RE: Environmental scoping for the relicensing of the Prairie Island Nuclear Generating Plant, Units 1 and 2

The Prairie Island Indian Community (Community or Tribe) would like to offer the following suggestions and comments regarding the scope of the draft Supplemental Environmental Impact Statement (SEIS) that will be prepared by the US Nuclear Regulatory Commission (NRC) for a 20-year operating license extension, as required by the National Environmental Policy Act (NEPA). The comments are offered in response to the notice in the Federal Register on July 22, 2008 (73 FR 42628).

Figure 2.

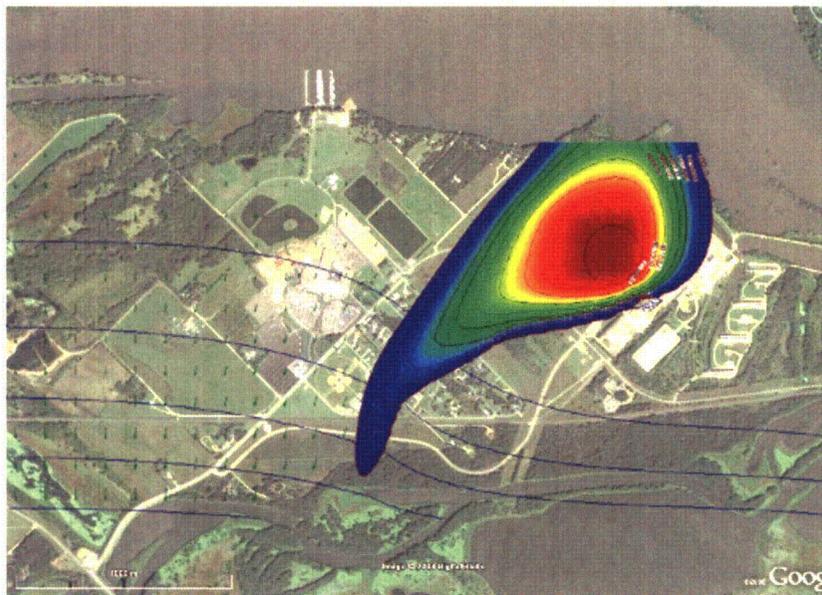
Figure 2, below, represents a simulated groundwater modeling showing the movement of tritium from the PINGP towards the Prairie Island Indian Community. The Community respectfully demands a full and complete disclosure of the monitoring data for all tritium and other radiological contaminants for each well or other monitoring location, and not simply monthly, quarterly or annual averages for individual wells. This data is critical to identify and baseline accidental and planned releases of tritium and other radiological contaminants, and to facilitate the Community's preparation of exposure scenarios, scenario analysis, and computer modeling of all environmental pathways for tritium contamination.

- The higher tritium concentration in onsite wells indicate that PINGP is the tritium source of PIIC wells (see Figure 2);
- No explanation was provided for off-site residence well contamination of tritium since 1989;

The SEIS must include an accurate quantification of radiological impacts to the members of the Prairie Island Indian Community—from all sources. At a minimum, the SEIS should include all data associated with all tritium and other radiological releases (accidental and planned), and all of the data for each well or other monitoring location (and not simply monthly, quarterly or annual averages for individual wells). This data is critical to identify and baseline accidental and planned releases of tritium and other radiological contaminants, and to facilitate the Community's preparation of exposure scenarios, scenario analysis, and computer modeling of all environmental pathways for tritium contamination.
